- Changes and errors:
1. The J11 input ground selection jumper is not useful.
 2. The footprint for U13 is incorrect on the PCB.
 3. Selection for ATXU13 should be via zero ohm resistors.
 4. 500 pF caps should be added to all RF inputs and outputs.
 5. HELA 10 amplifiers are covered with solder mask on PCB.
 6. Remove L16 and C79.
 7. Need test points on the band pass filter to facilitate tuning.
 8. Add a block on PCB to write what the attenuator settings are.

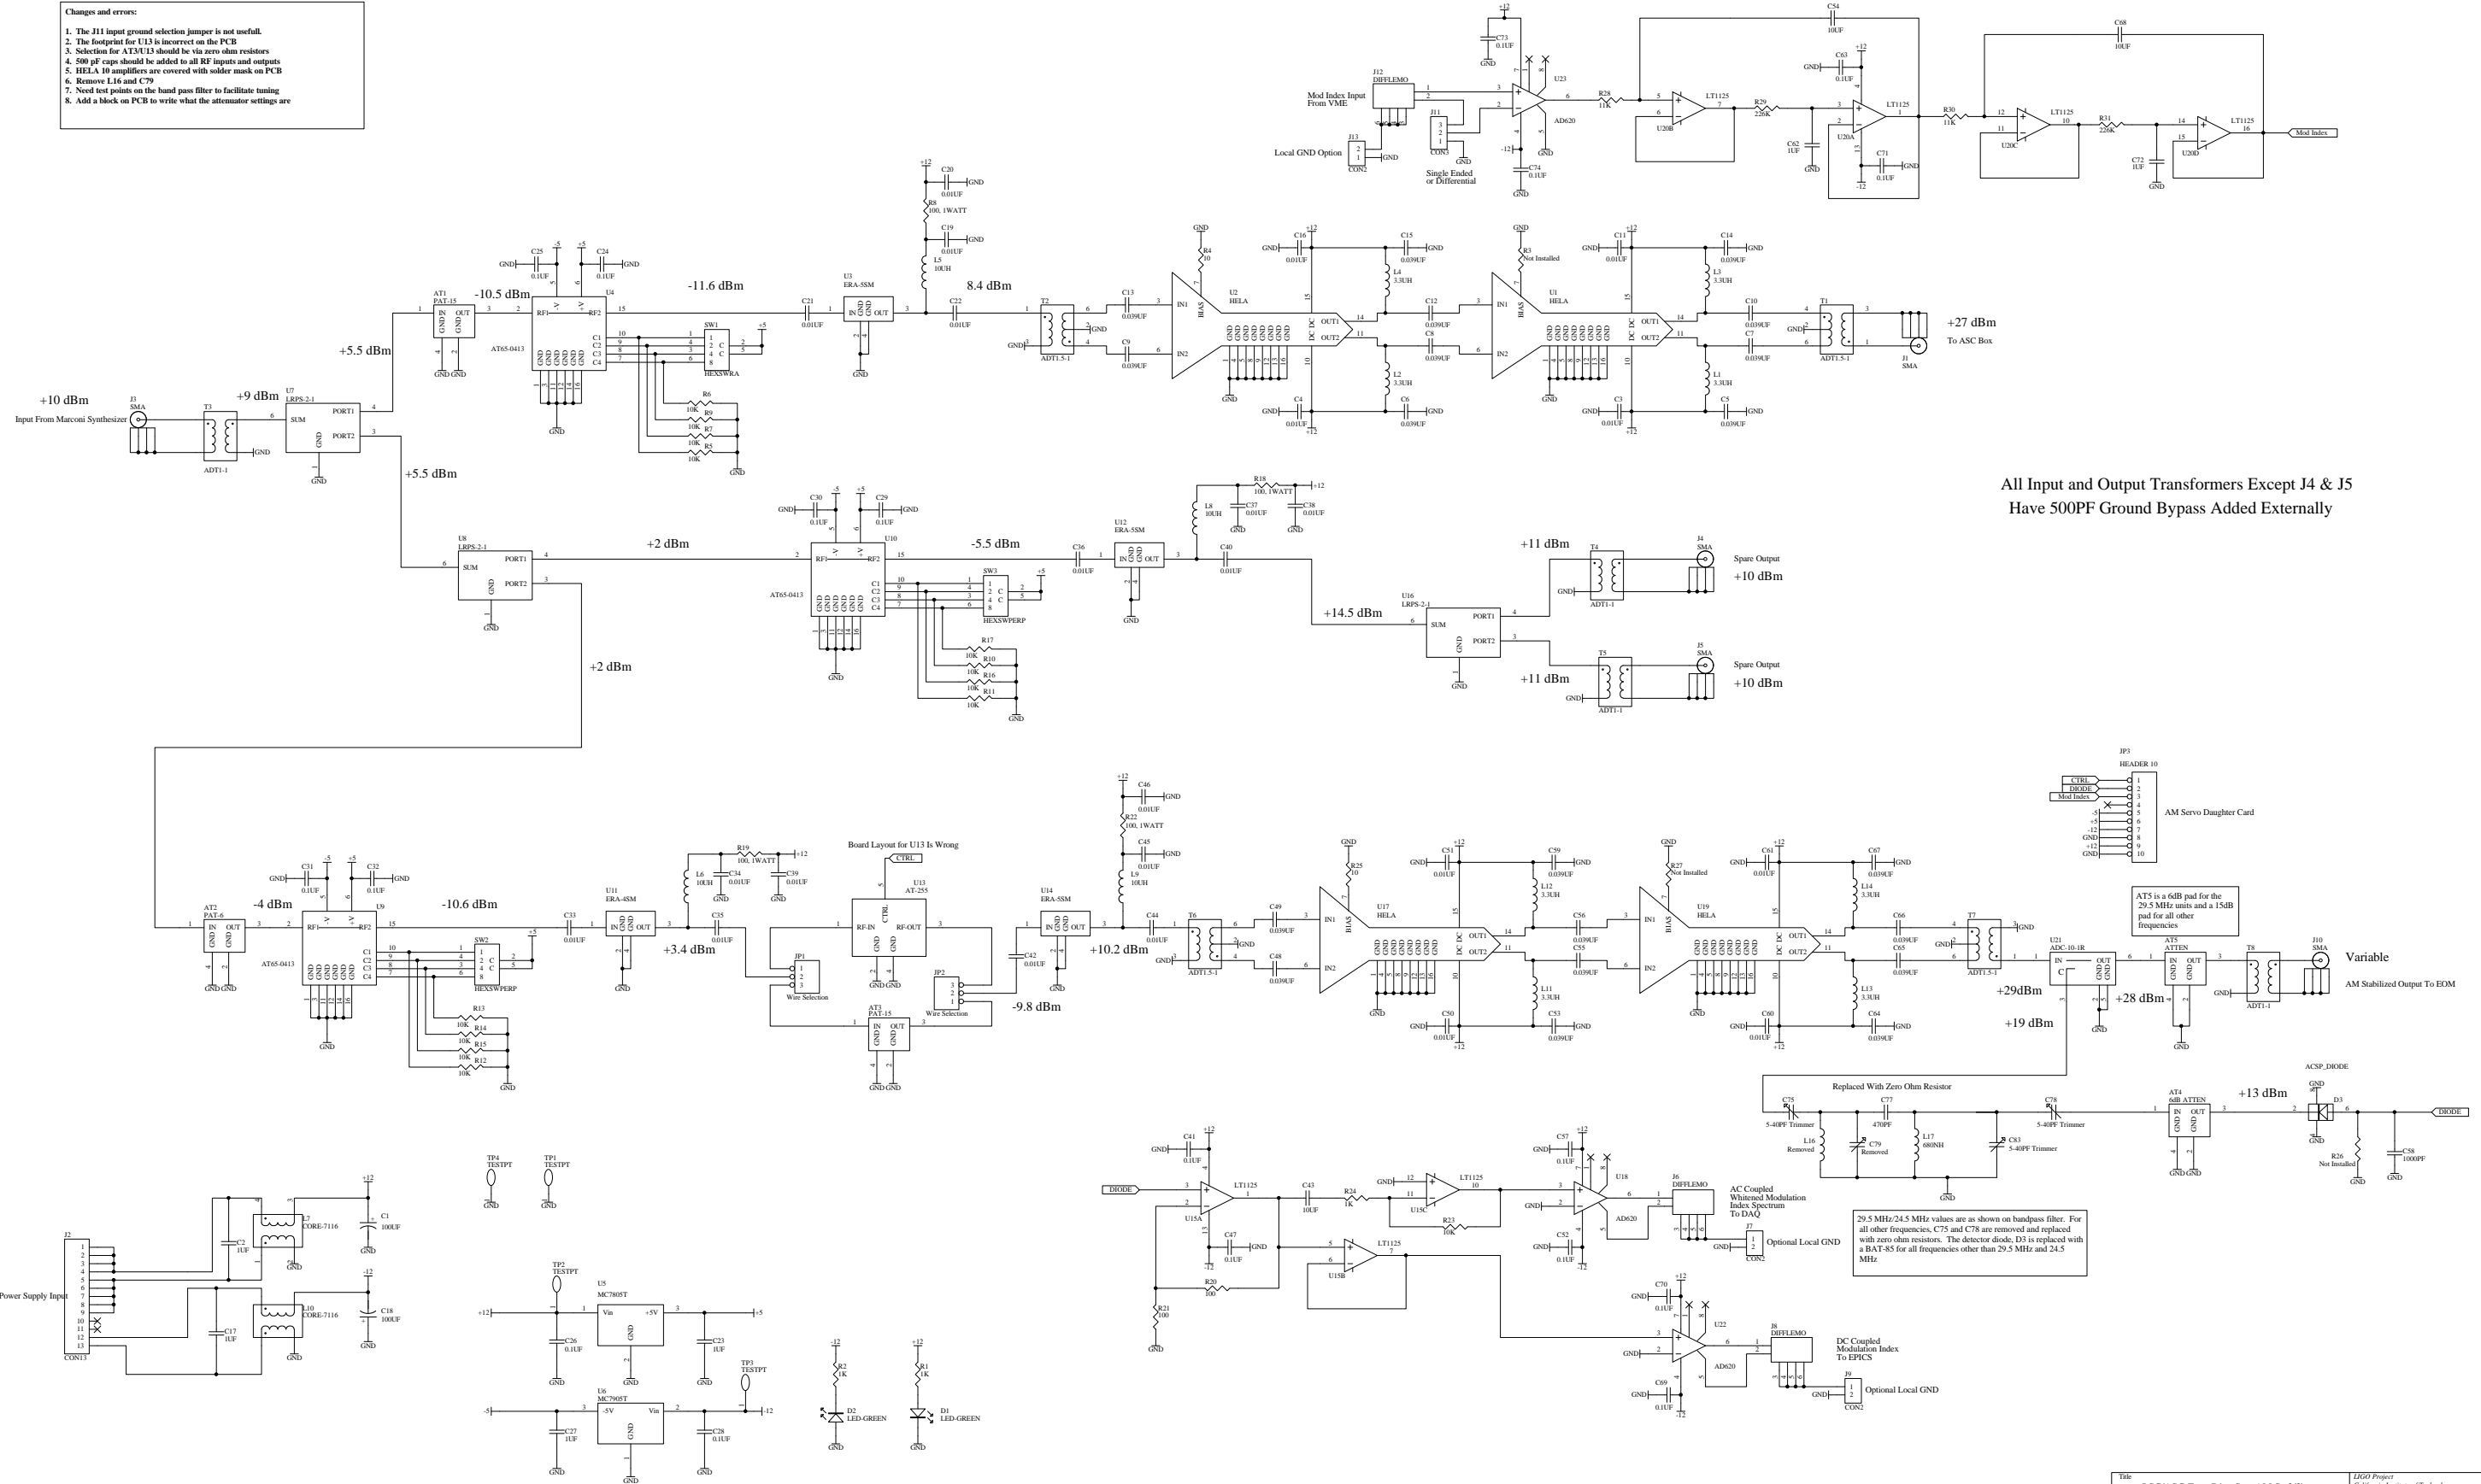
All Input and Output Transformers Except J4 & J5
Have 500PF Ground Bypass Added Externally

Replaced With Zero Ohm Resistor
